Project Name
Gorton
Mount Road

Drawing Title
Proposed Elevations (W. and S.)
(Amendments Identification)

Drawing Number
GMR-KMA-XX-XX-DR-A-7102

PROPOSED ELEVATION (WEST)

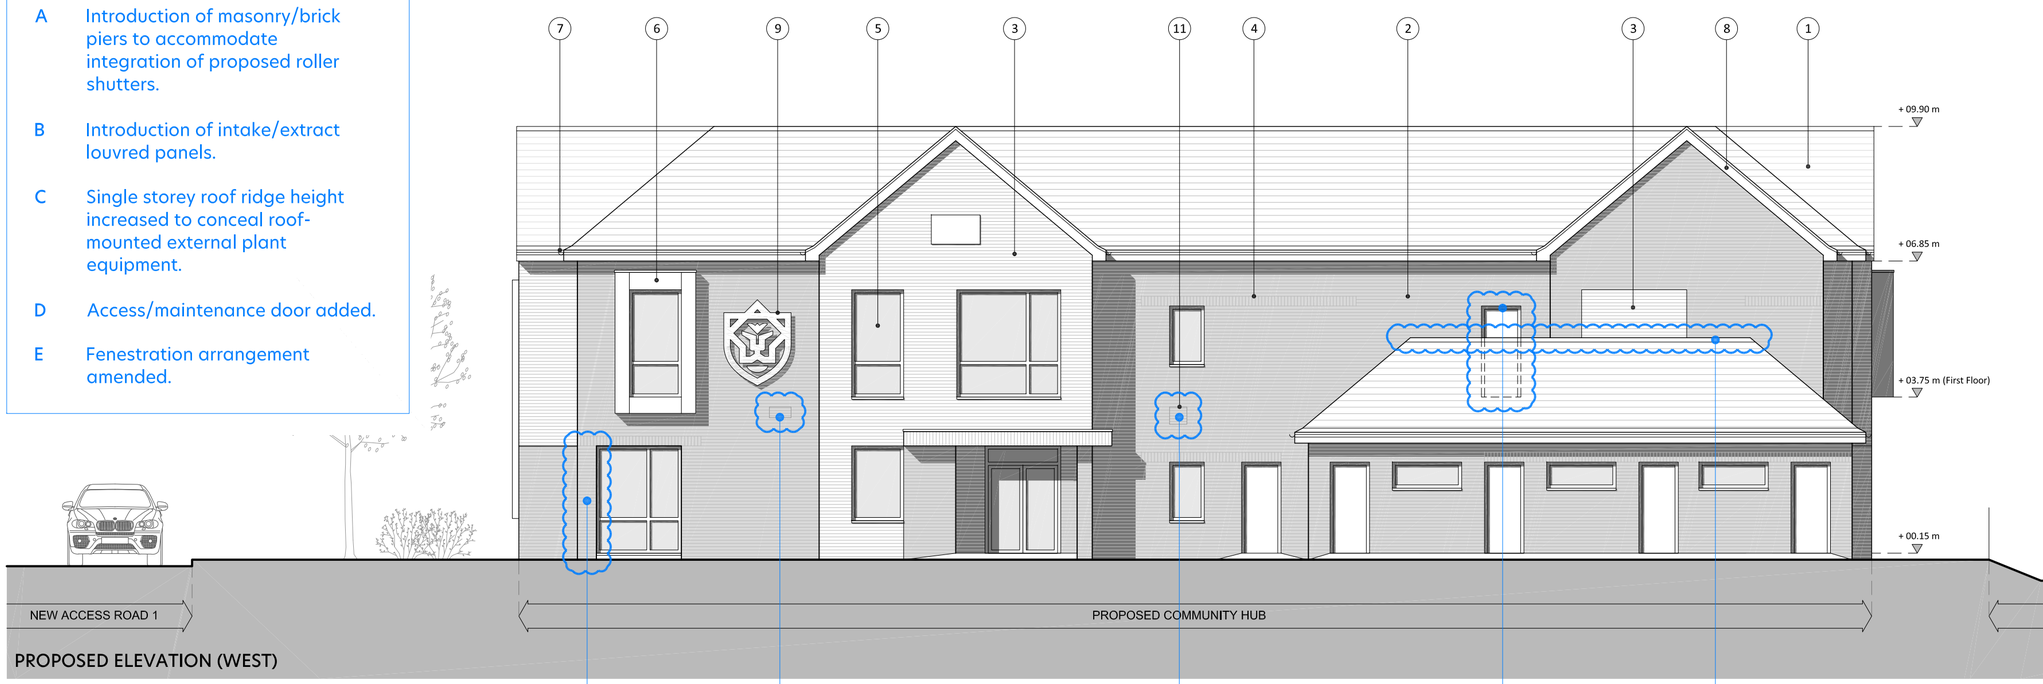
A Introduction of masonry/brick piers to accommodate integration of proposed roller shutters.

B Introduction of intake/extract louvred panels.

C Single storey roof ridge height increased to conceal roof-mounted external plant equipment.

D Access/maintenance door added.

E Fenestration arrangement amended.
